ADDENDUM NO. 2  
Appoquinimink School District  
Silver Lake Elementary School  
Additions and Renovations – Bid Package 'A'  
Page 1

The contract documents for the above referenced project, dated December 6, 2019 are amended as follows:

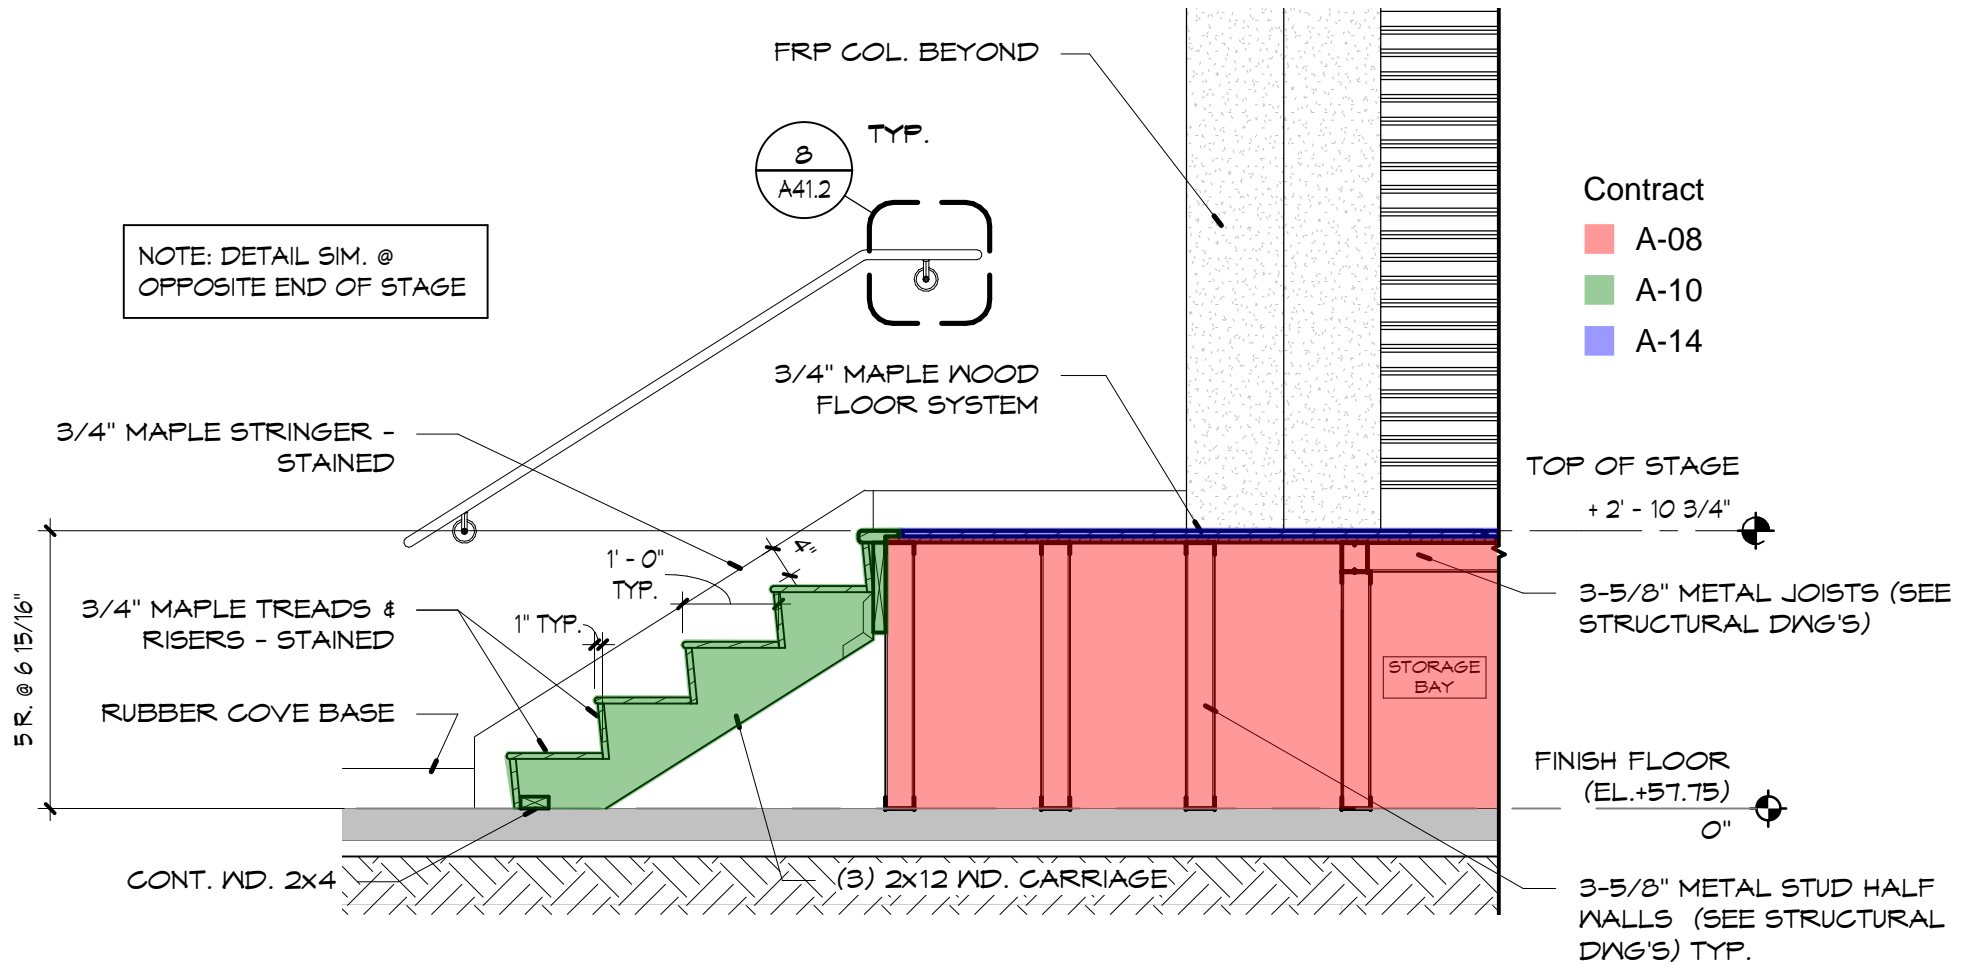
- 1.) With the stage flooring being supplied by Contract A14, the stair treads/risers by A06, and the stage front by A10, there is always the issue of the stage overhang (HIGHLIGHTED ON THE ATTACHED DRAWING) and who is to supply this. The other issue is you will have is trying to match finishes by 3 different contracts will be extremely difficult.

- 1.) Refer to Addendum #2 for detailed revisions clarifying the scope and interface of scope for contracts responsible for his work.

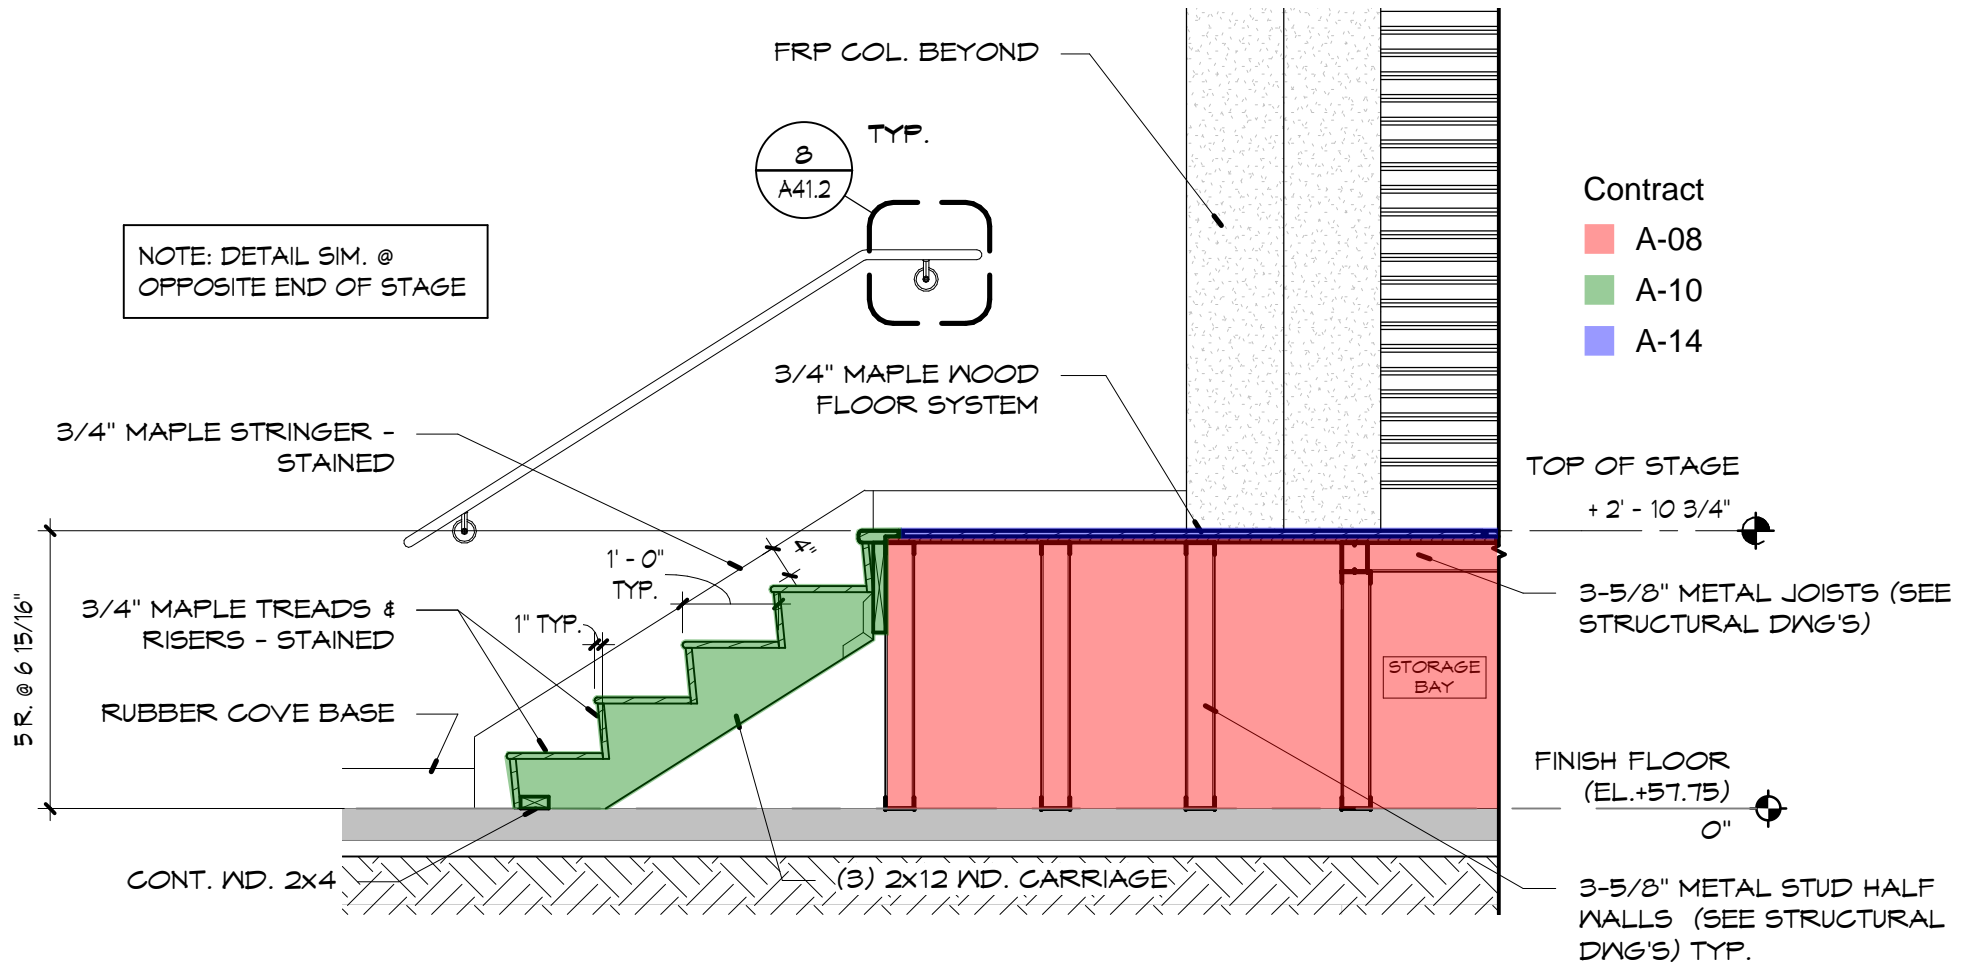
- 1.) The front nosing at the stage is integral to the flooring system. The same nosing/flooring system should extend out to the edges of the wing walls (3/A41.2) at the treads and risers so there is no difference in material/finish. Verify this is part of the A-06 package and not A-10.

- 1.) See attached sketch. Refer to Addendum #2 for detailed revisions clarifying the responsibilities as it relates to the stage.
